Access Compliance Report

Public Rights-of-Way

Intersection ID: 22882	Main Street: SARDIS_POINTE_RD	Cross Street: SARDIS_RD	Location: W
ADA ID: AF8C923AAC0F	Ramp Type: Perp	Initial Pass/Fail: Fail	Overall Compliance: No
		Severity Score: 25

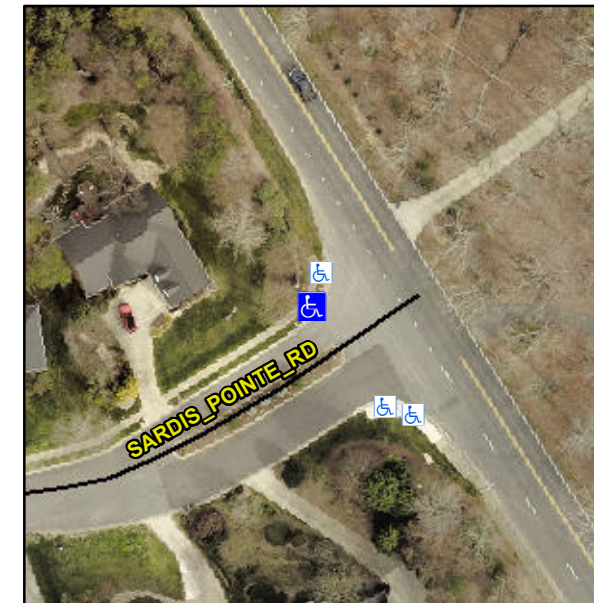
Not Found, R304.5.3

Compliance	Description	Data	Compliance	Description	Data
N/A	Ramp Length (in)	50.0	Yes	Ramp Slope (%)	5.4
Yes	Ramp Width (in)	48.0	No	Ramp XSlope (%)	9.0
N/A	Flare Type LT	N/A	N/A	Flare Type RT	N/A
N/A	Flare Slope LT (%)	N/A	N/A	Flare Slope RT (%)	N/A
N/A	Flare Traversable LT?	N/A	N/A	Flare Traversable RT?	N/A
N/A	Landing Length (in)	N/A	N/A	DWS Provided?	N/A
N/A	Landing Width (in)	N/A	N/A	DWS Contrast?	N/A
N/A	Landing Slope (%)	N/A	N/A	DWS Length (in)	N/A
N/A	Landing X Slope (%)	N/A	N/A	DWS Full Width?	N/A
N/A	Landing Curb? (Y/N)	N/A	N/A	DWS Offset (in)	N/A
N/A	Shared Landing?	N/A			
N/A	Gutter Ponding?	N/A	N/A	Gutter Slope (%)	N/A
N/A	Gutter Lip Ht (in)	N/A	N/A	Gutter X Slope (%)	N/A
N/A	Painted X Walk1?	No	N/A	Painted X Walk2?	N/A
	X Walk 1 Direction	To SE		X Walk 2 Direction	N/A
N/A	X Walk 1 Width (in)	N/A	N/A	X Walk 2 Width (in)	N/A
	X Walk 1 Slope (%)	0.2		X Walk 2 Slope (%)	N/A
	X Walk 1 X Slope (%)	7.3		X Walk 2 X Slope (%)	N/A

Remove & Replace Entire Ramp.
